Re: **PETITION NO. 1442 - SR Litchfield, LLC petition for a declaratory ruling, pursuant to Connecticut General Statutes §4-176 and §16-50k, for the proposed construction, maintenance and operation of a 19.8-megawatt AC solar photovoltaic electric generating facility on 6 contiguous parcels located both east and west of Wilson Road south of the intersection with Litchfield Town Farm Road in Litchfield, Connecticut, and both east and west of Rossi Road, south of the intersection with Highland Avenue in Torrington, Connecticut, and associated electrical interconnection.**

### **Partial D&M Plan III – Responses to Council Interrogatories**

**RESPONSES OF SR LITCHFIELD, LLC  
TO CONNECTICUT SITING COUNCIL INTERROGATORIES  
PARTIAL DEVELOPMENT AND MANAGEMENT PLAN III**

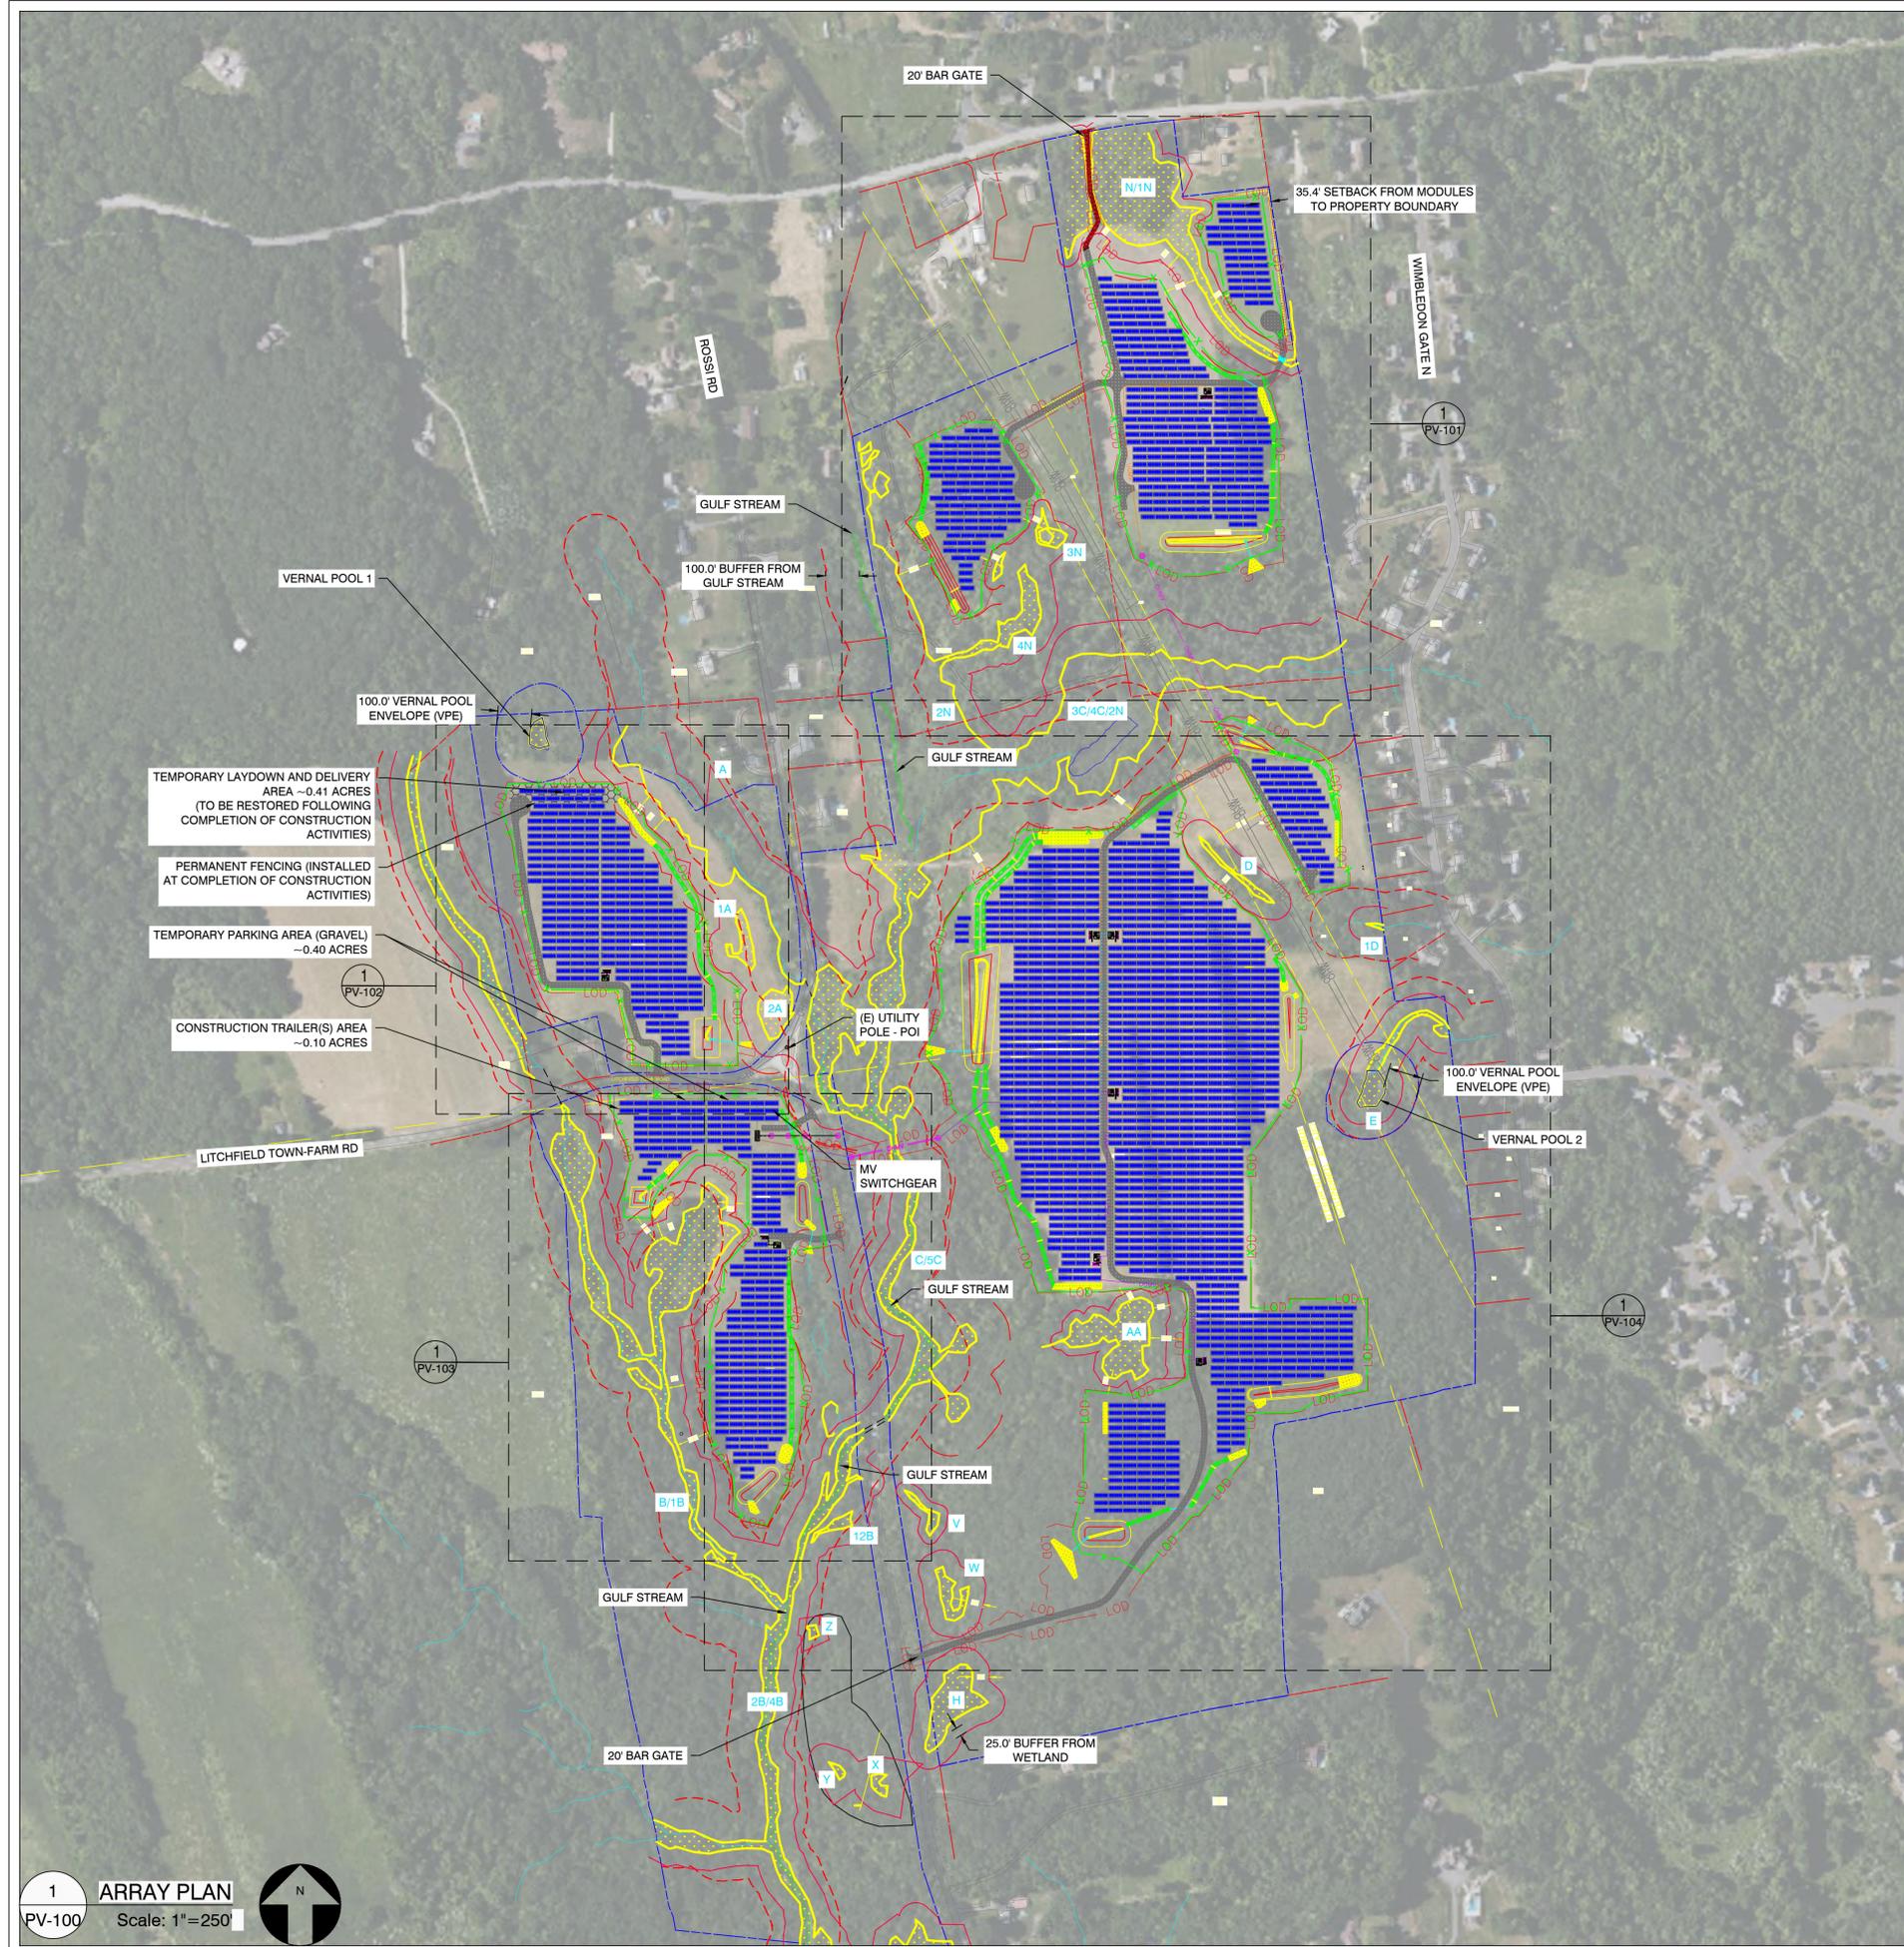
Electrical Site Plan PV-001 states the closest distance from a solar panel to a perimeter fence is 4.5 feet. Where is this location?

SRL understands the reference to Electrical Site Plan PV-001 to be to PV-100 in Attachment 1 (Racking Engineering Plans), which is also PV-100 in Attachment 3 (Site Layout and Array Details).

The same typographical error 4.5 feet measurement was also on G-101 in Attachment 1 (Racking Engineering Plans). This will be updated before construction of the modules and perimeter fencing begins.

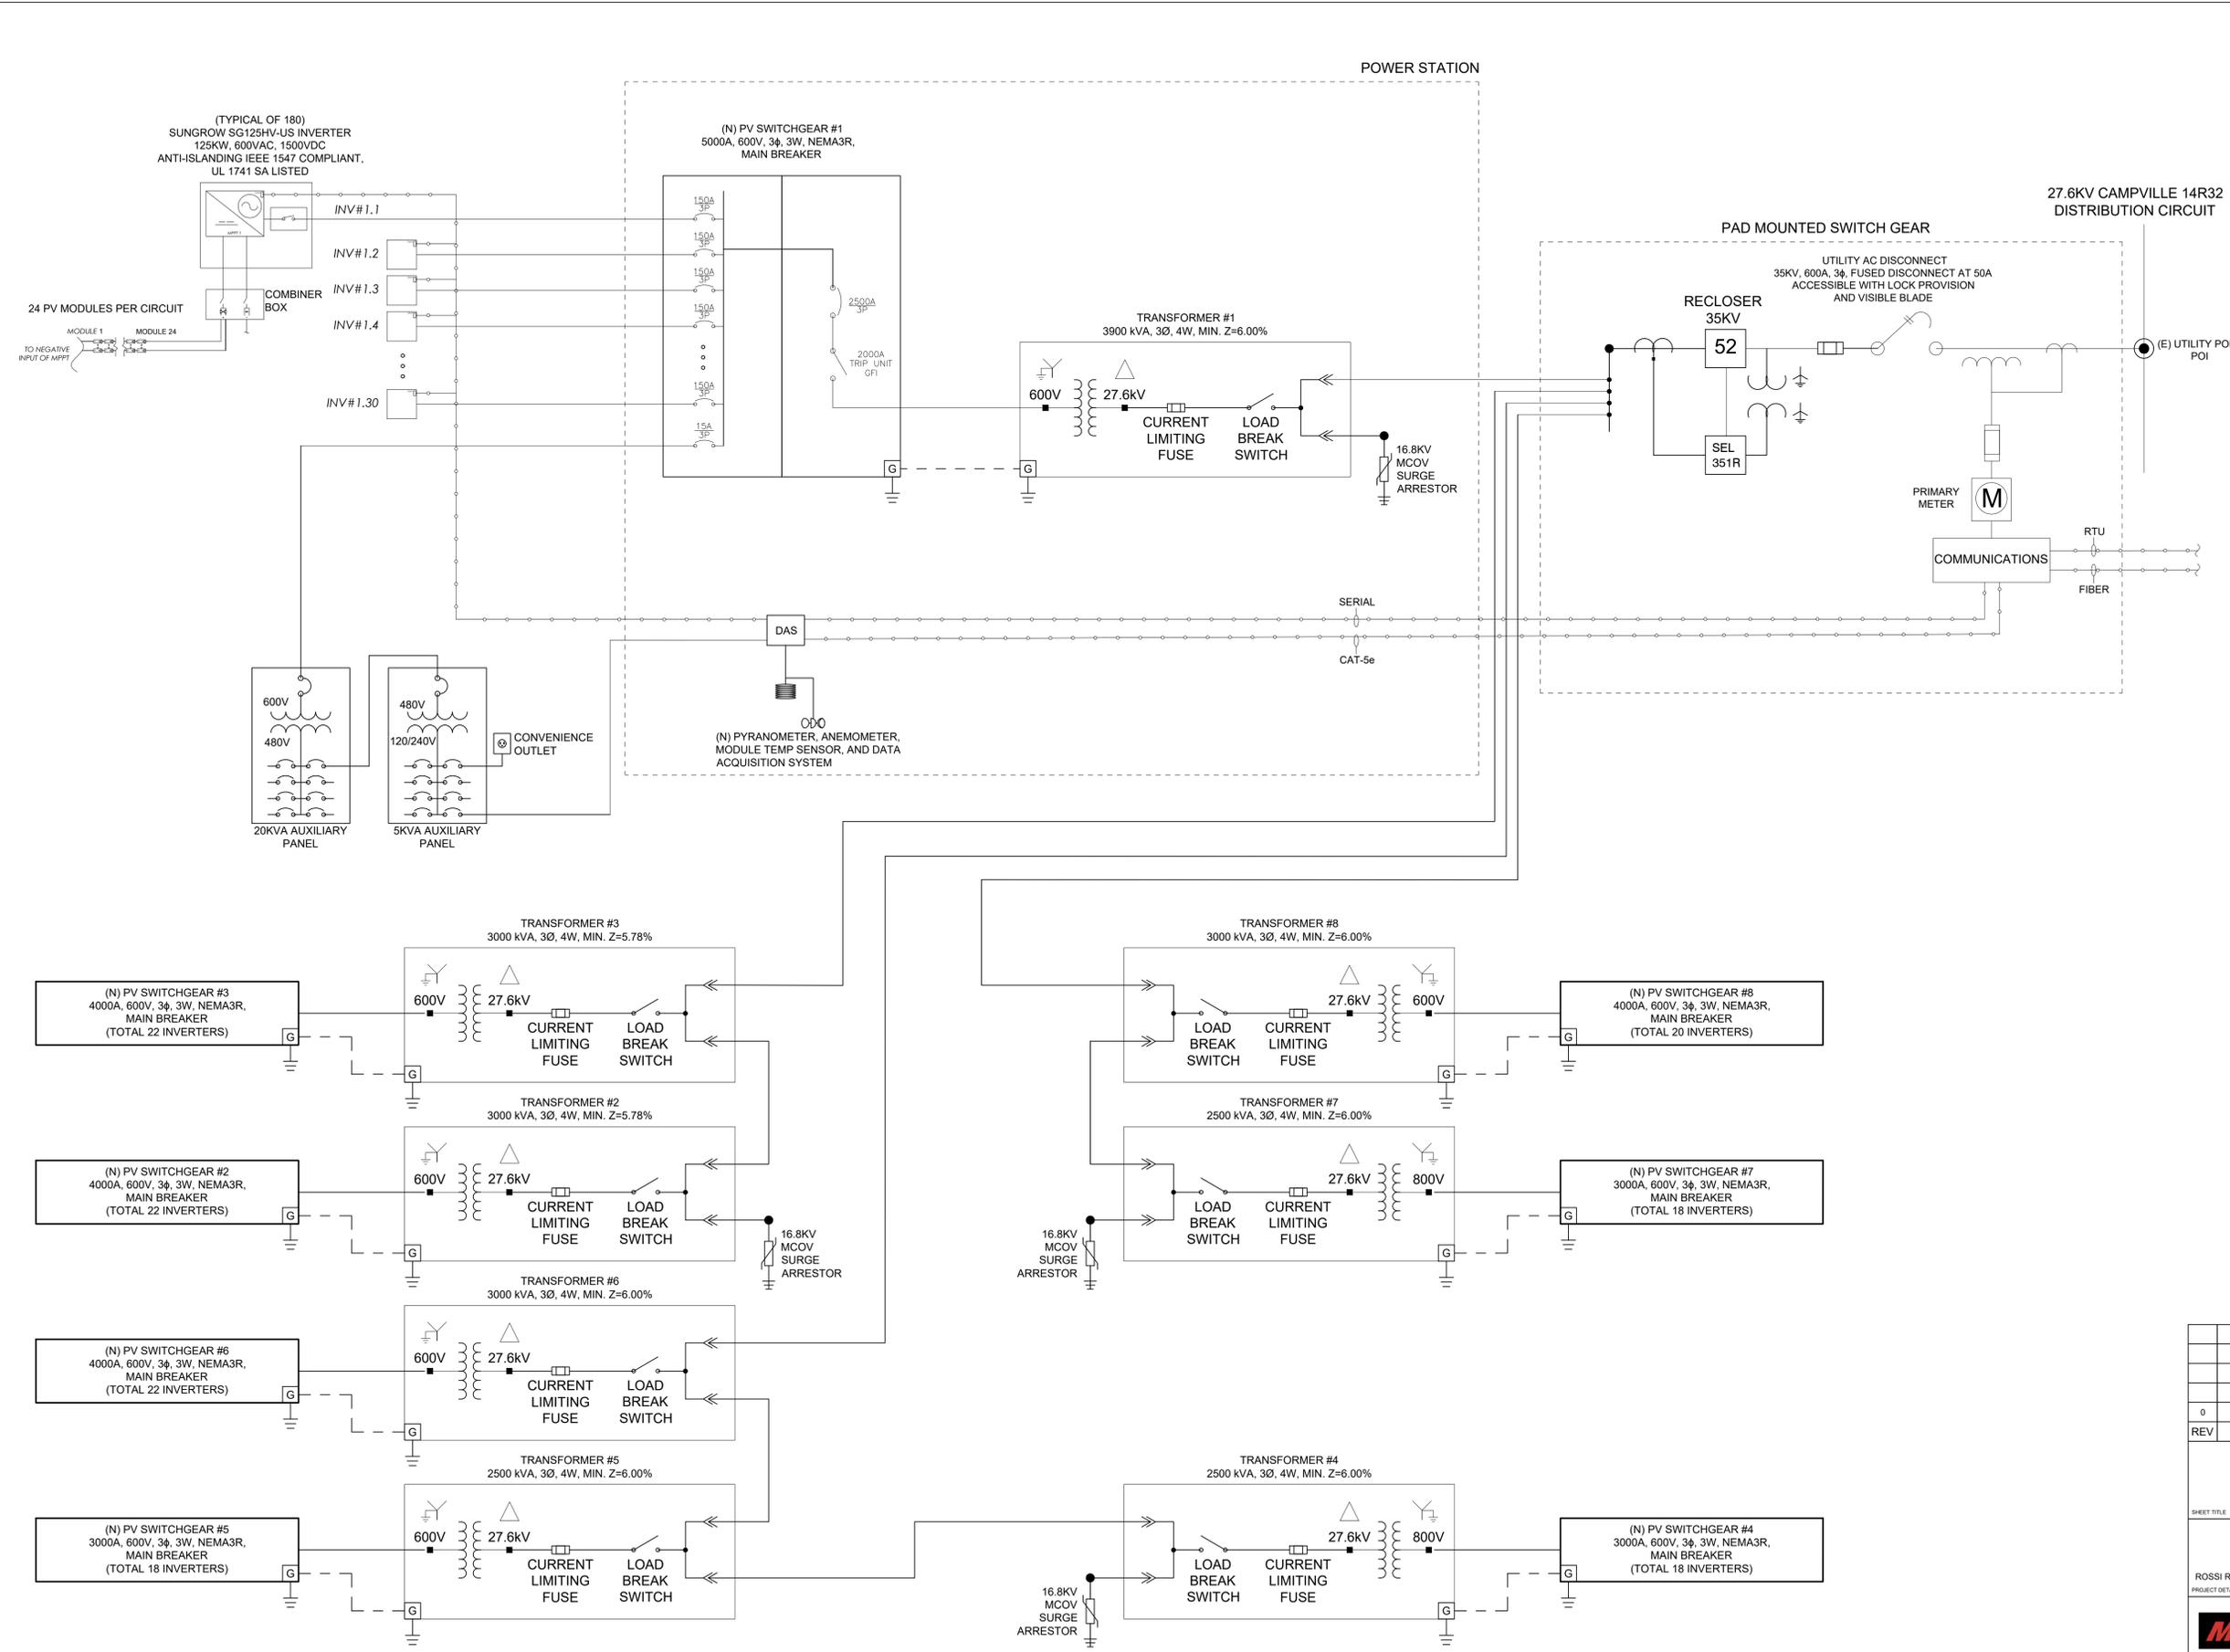
The Petition Noise Impact Assessment dated December 2, 2020 (Exhibit N), was based on a project design with 90 inverters. Electrical Site Plan G-001 indicates 170 inverters will be installed as part of a project re-design. Revise the Noise Impact Assessment to account for the project re-design. Will the project re-design meet DEEP Noise Control Regulations at the boundaries of the host parcels?

An updated Noise Impact Assessment of the latest Project design was conducted on November 21, 2023. The preliminary results show that the latest Project design meets DEEP Noise Control Regulations at all nearby residences surrounding the Project. *See Attachment C.*

A final updated Noise Impact Assessment report supporting that conclusion is expected by December 7, 2023. SRL will submit a copy to the Council when it is received. If the Council elects to approve SRL's Phase III D&M Plan prior to that submission, then SRL would be pleased to have as a condition of approval the submission of the final updated Noise Impact Assessment report demonstrating compliance with the CT DEEP Noise Control regulations.
